FORM APPROVED
OMB No. 1004-0135
Expires November 30, 2000**SUNDRY NOTICES AND REPORTS ON WELLS**
Do not use this form for proposals to drill or to re-enter an abandoned well. Use Form 3160-3 (APD) for such proposals.

BIG EDDY UNIT #162

BPCO, L.P. RESPECTFULLY REQUEST TO REPLACE DIAGRAM 2 FILED WITH THE BEU #162 APD WITH THE REVISED DIAGRAM 2 ATTACHED HERETO.

DIAGRAM 2

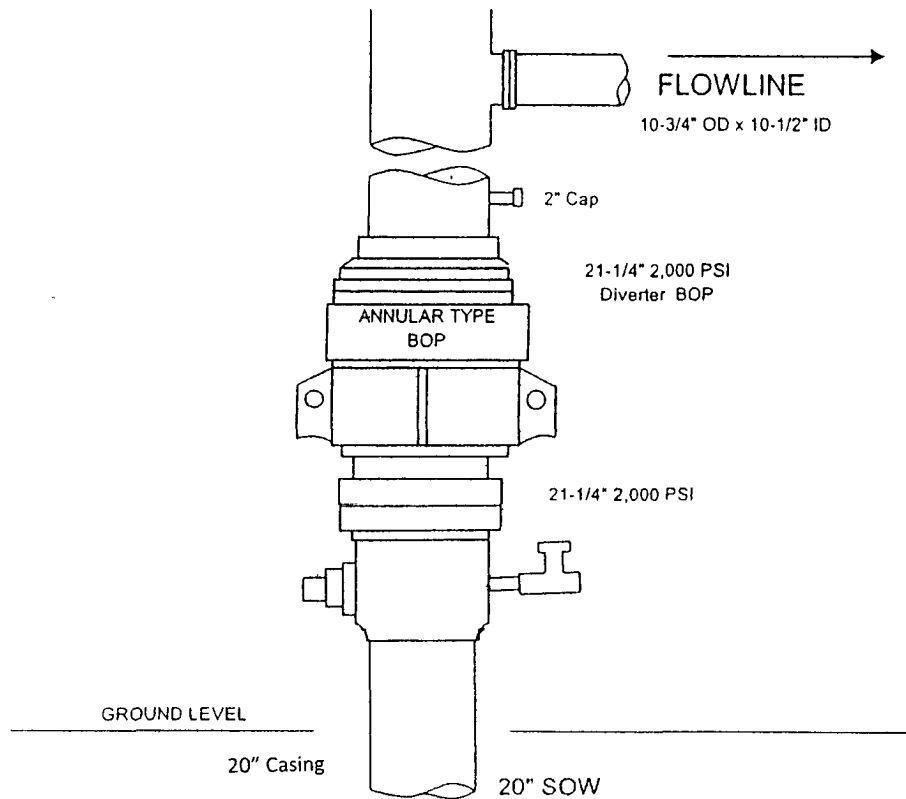
*2" kill line + valve required.
choke line valve required (2")
choke manifold required,*
